Proposed Change 1857

Code Reference(s):	NECB20 Div.B 13.3. (first printing)
Subject:	Alteration of Existing Buildings
Title:	Alteration of the Building Envelope
Description:	This proposed change adds requirements defining the application of NECB Part 3 to the building envelope subjected to alteration.
Related Proposed Change(s):	PCF 1862

Figure 1. Marginal energy use intensity increment for various building archetypes and vintages in regions across Canada

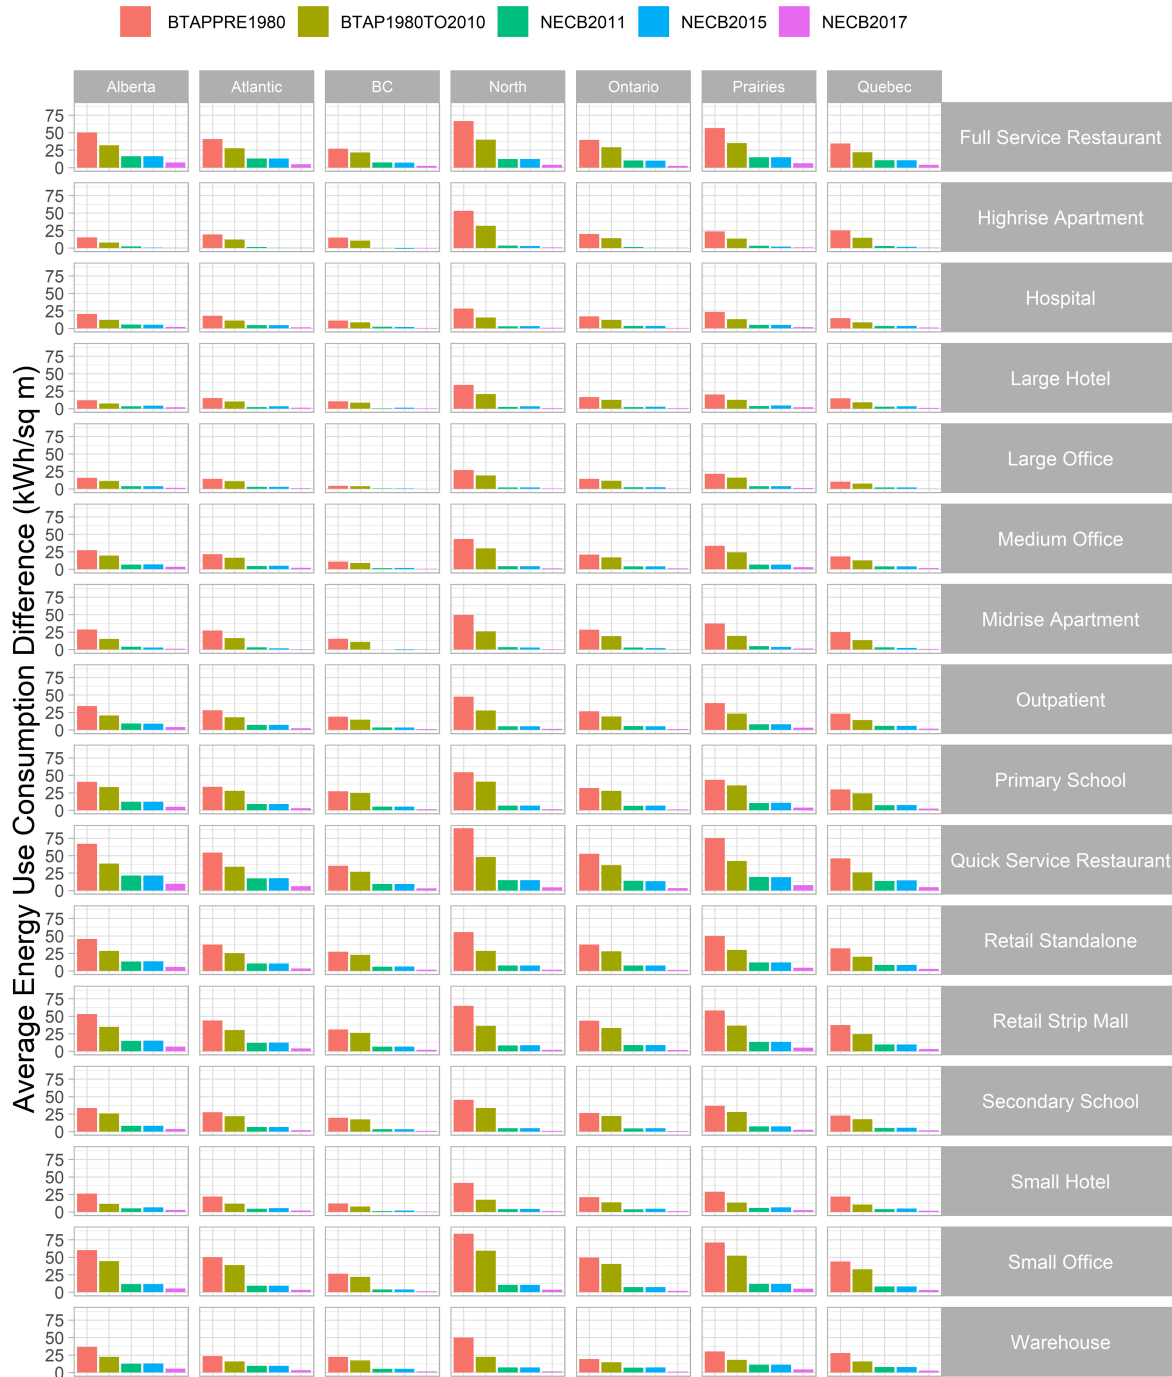
Summary results from the simulations are presented by region in Figure 1 (thermal energy use intensity (TEUI) reduction, kWh/m²) and Figure 2 (percentage reduction); positive values indicate energy savings.

Generally, buildings of older vintages are less insulated, therefore, upgrading the insulation to NECB 2020 levels result in higher energy savings; this saving diminishes for newer vintages as the difference in thermal transmittance also diminishes, as presented in Figure 1. However, there are exceptions. A comparison of the energy savings of the NECB 2011 and NECB 2015 vintages of most building archetypes show nearly identical values because the base prescriptive thermal transmittances of the building envelope (window and opaque surfaces) are the same in the NECB 2011 and NECB 2015. Some building archetypes, on the other hand, do not exhibit either trend.

The results for small and large hotels in the NECB 2015 and NECB 2011 vintages show that the NECB 2015 energy savings are greater than those of the NECB 2011 (e.g., see Figure 1), even though both vintages contain the same building envelope (base and upgraded). This is a result of comparing the TEUI, which encompasses the energy differences of other aspects of the building. The lighting and hot water loads decreased in the NECB 2015 vintage compared to the NECB 2011 vintage, resulting in a building

Similarly, the multi-unit residential buildings (mid- and high-rises) also form an irregular case; in Figure 1, the savings are negligible (Atlantic region) or sometimes negative (BC), i.e., increased energy consumption occurs after upgrading the building envelope to the NECB 2020 requirements. While increasing insulation decreased the heating load, it also increased the building's cooling load. The balance of these competing energy loads is highly influenced by the location's climate; therefore, additional cooling energy may outweigh energy savings from reduced heating for archetypes that experience a comparatively mild winter and hot summer.

Figure 3. Heat loss intensity of the building envelope (based on floor area) for various Canadian archetypes and vintages

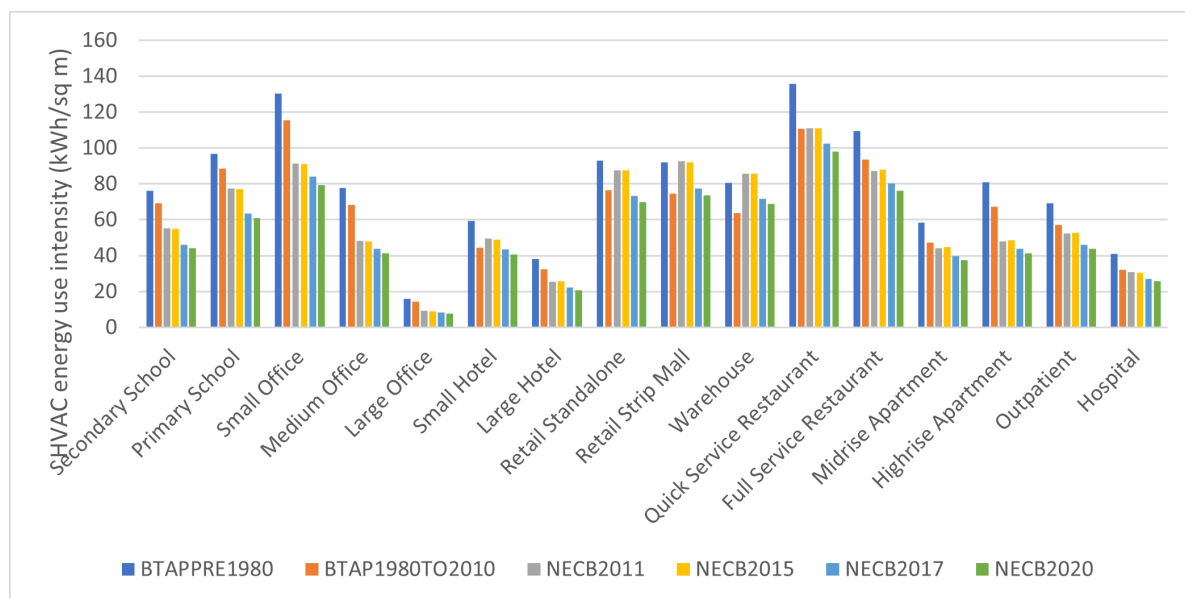
Figure 3 presents the heat loss per floor area (kWh/m^2) of the building envelope for each archetype, averaged over the 32 locations. The trend of diminishing energy savings for progressively newer building vintages, seen in Figure 1, is also observed in Figure 3. However, the exception found in Figure 3 is the higher heat loss of the building envelope in the NECB 2011 and NECB 2015 vintages, compared to the older Pre-1980 and 1980–2010 vintages. The older archetypes use, as a default, the FDWRs set by the U.S. DOE for the commercial archetypes that are generally lower than prescriptively set in the NECB 2011 and NECB 2015, resulting in a more insulating building envelope overall. Table 1 presents the range of FDWR of these archetypes for the different vintages. Note that these archetypes can obtain similar or better performing results for the building envelope than in the pre-2010 vintage ($\text{FDWR} < 0.11$), while maintaining the larger FDWR of the NECB 2011/NECB 2015 ($\text{FDWR} \geq 0.2$), by using the more stringent thermal transmittance values found in the NECB 2017.
